## McMicken Dam Outlet Channel - Alternative 4

### FINAL Value Analysis Study Report Flood Control District of Maricopa County McMicken Dam Outlet Channel Project October 2014

**RE: McMicken Dam Outlet Channel Project  
Value Analysis Study–Final VA Report**

**TITLE:** Start Alternative 4 immediately after the road to eliminate possible levee conditions

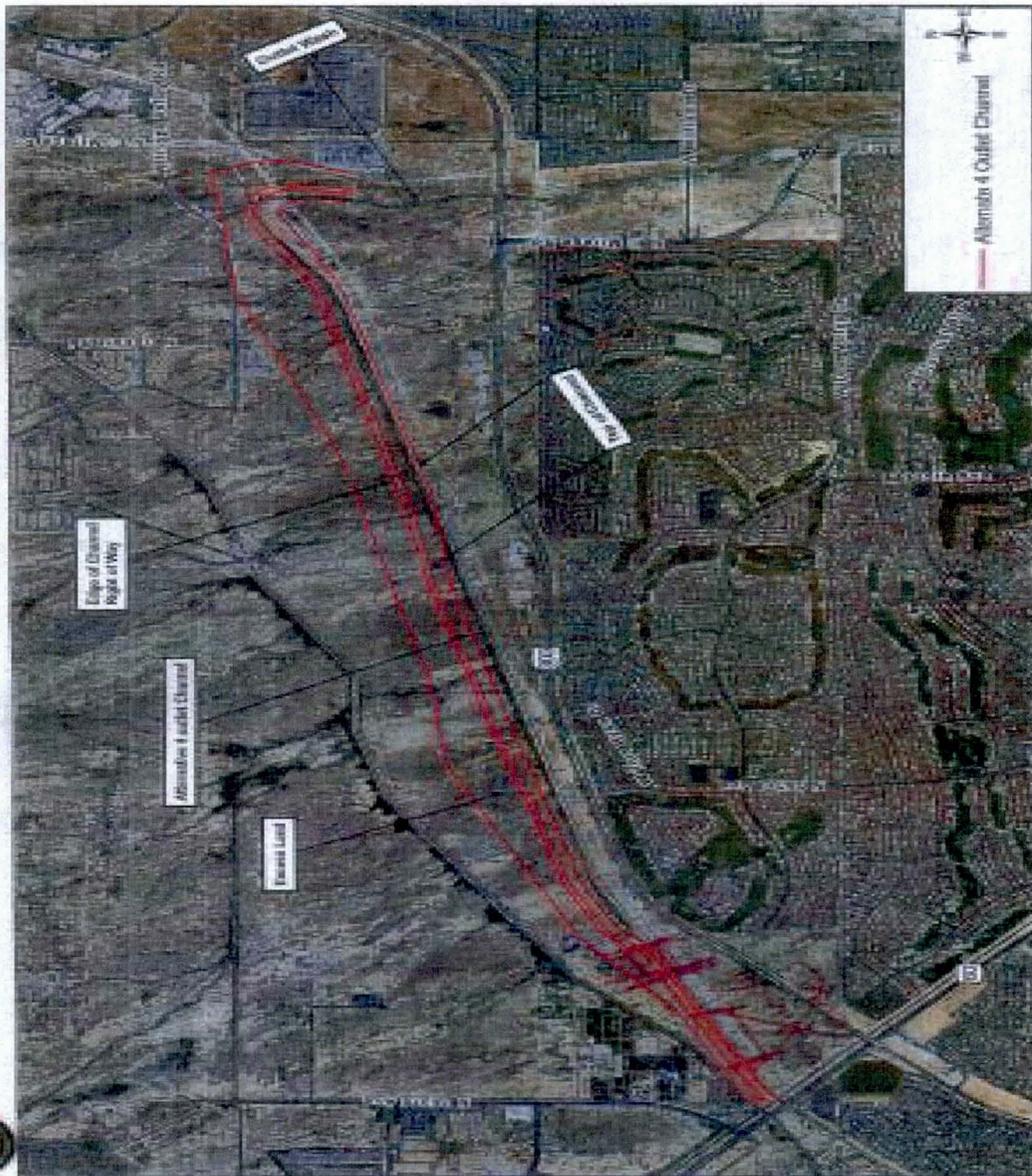
<b>TITLE:</b> Start Alternative 4 immediately after the road to eliminate possible levee conditions	
<b>FUNCTION:</b> Miscellaneous	
<b>BASELINE ASSUMPTION:</b> Outlet Channel Alternative 4 begins at Sta 111+00.	
<b>PROPOSED ALTERNATIVE:</b> Change the start of the Alternative to begin at Sta 105+00.	
<b>BENEFITS</b>	<b>RISKS/CHALLENGES</b>
<ul style="list-style-type: none"> <li>• Potentially eliminates levee condition for 4450 cfs</li> </ul>	<ul style="list-style-type: none"> <li>• 100 year flow is about 2800 cfs which is likely to be below natural grade</li> </ul>
<ul style="list-style-type: none"> <li>•</li> </ul>	<ul style="list-style-type: none"> <li>• Changing alignment earlier would increase excavation and construction cost with no regulatory benefit</li> </ul>
<ul style="list-style-type: none"> <li>•</li> </ul>	<ul style="list-style-type: none"> <li>• Transmission tower at Sta 108+00 precludes shifting Alternative 4 turnoff earlier/upstream</li> </ul>

## **DD-01 Reduce bed slope to 0.1%**

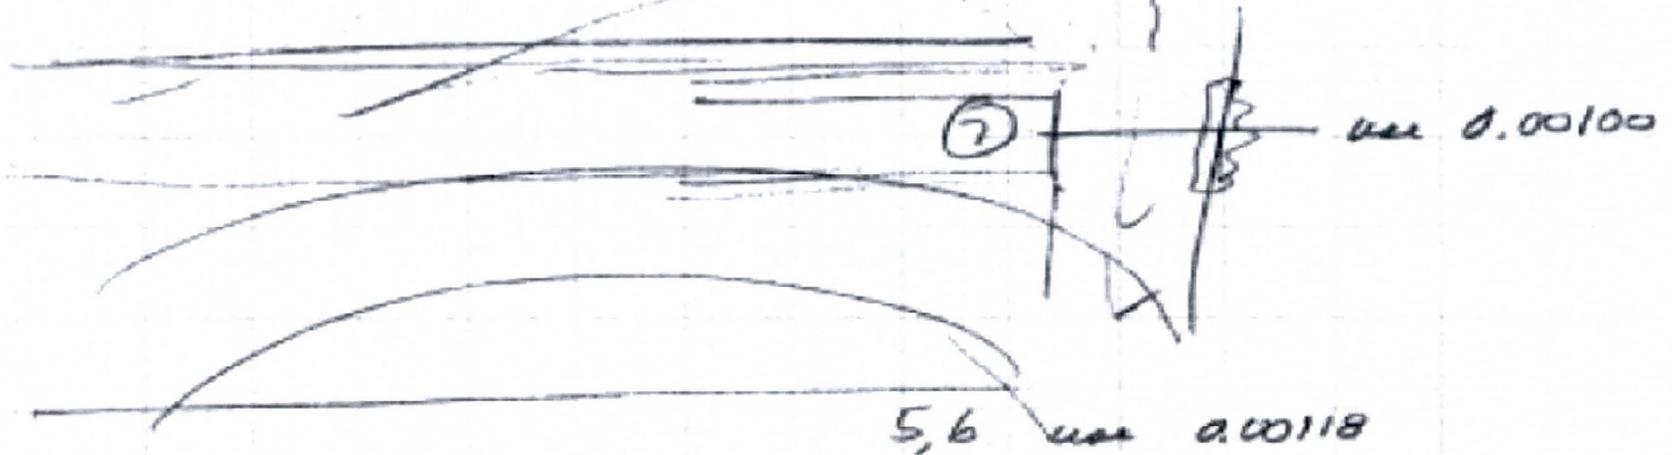
→ FLOW METER @ EACH FLOW RATE  
4450, 7025, 9090  
SE MP/MPH

## **DD-12 Vary the cross-section to protect existing trees – use a low flow channel**

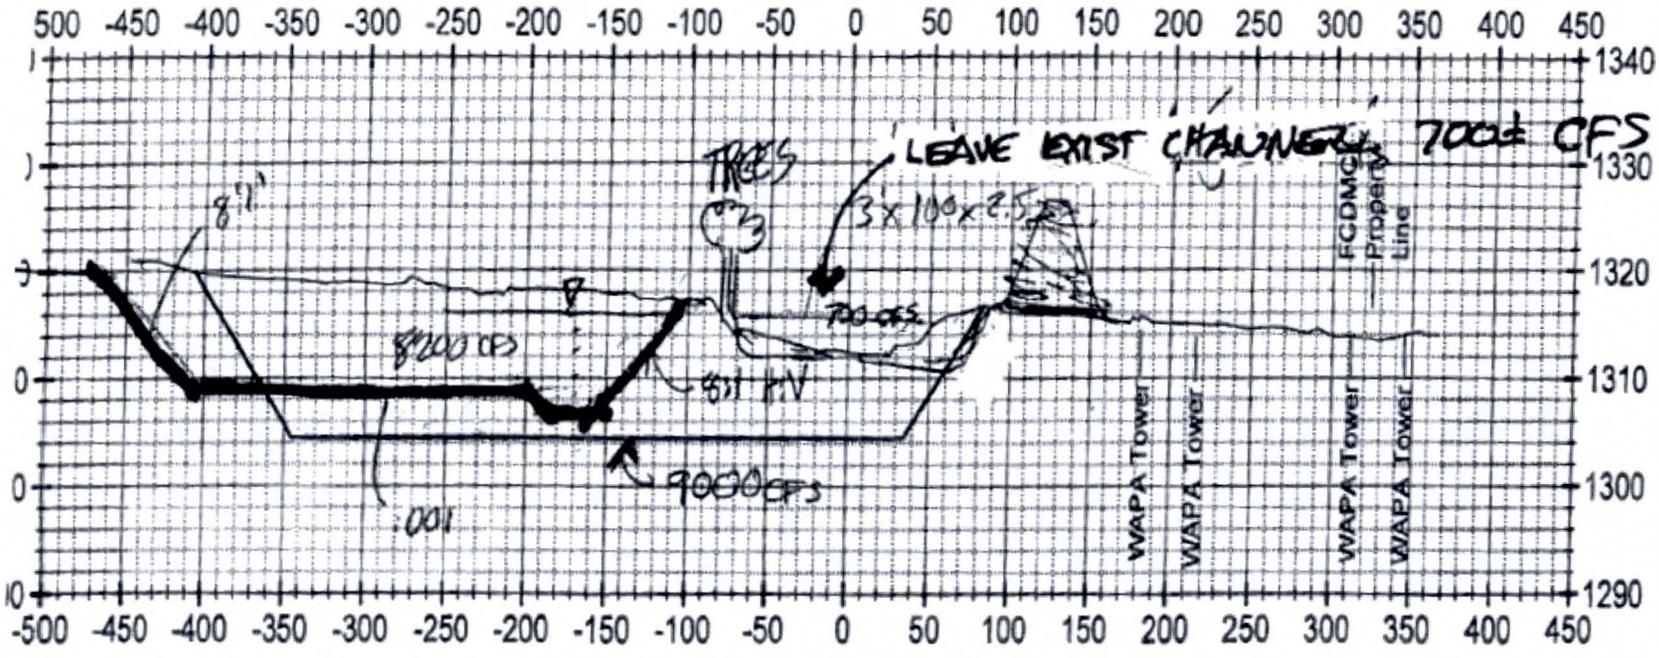
- Reduces excavation/cost
- Preserves trees

## **DD-16, 21, 22 Use basins**

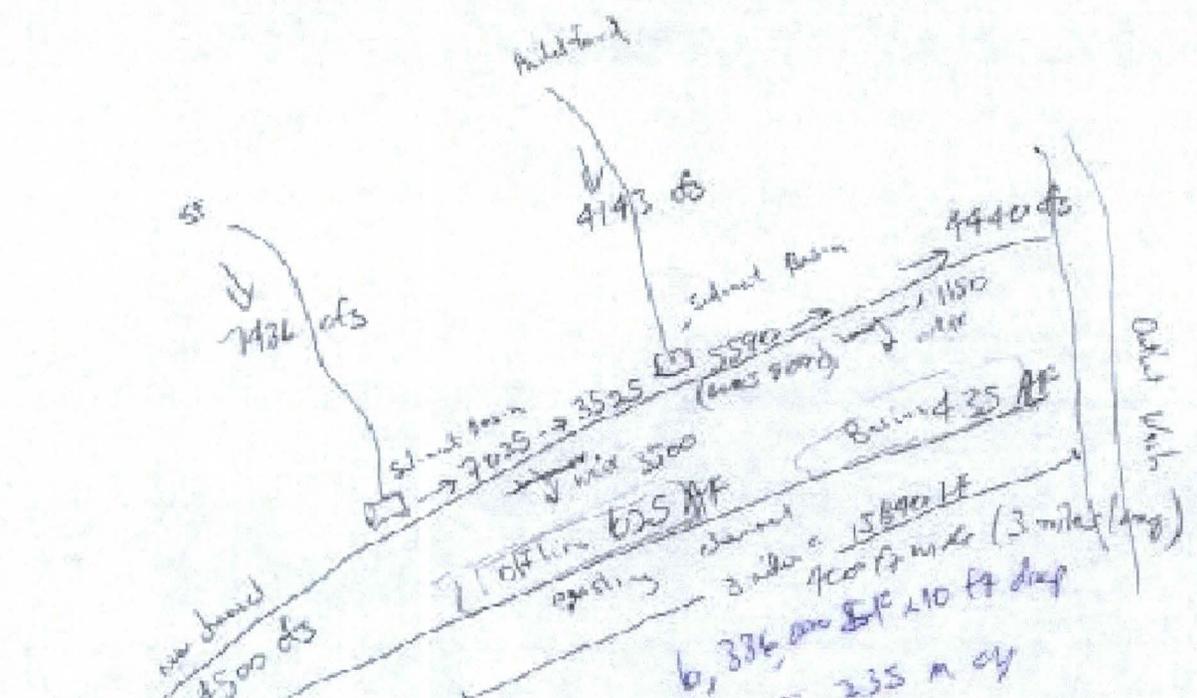
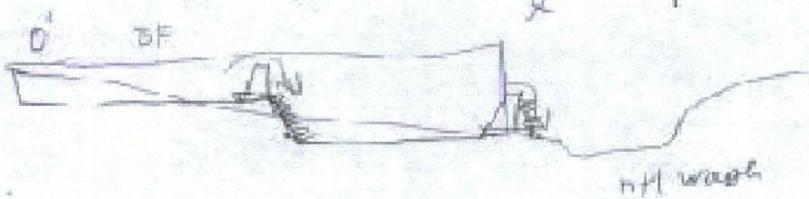
- Reduces proposed channel size
- Increases saleable land area/cost
- Optimizes use of old channel
- Recharge/wetland basins can be incorporated into main storage basin
- Optimizes channel storage
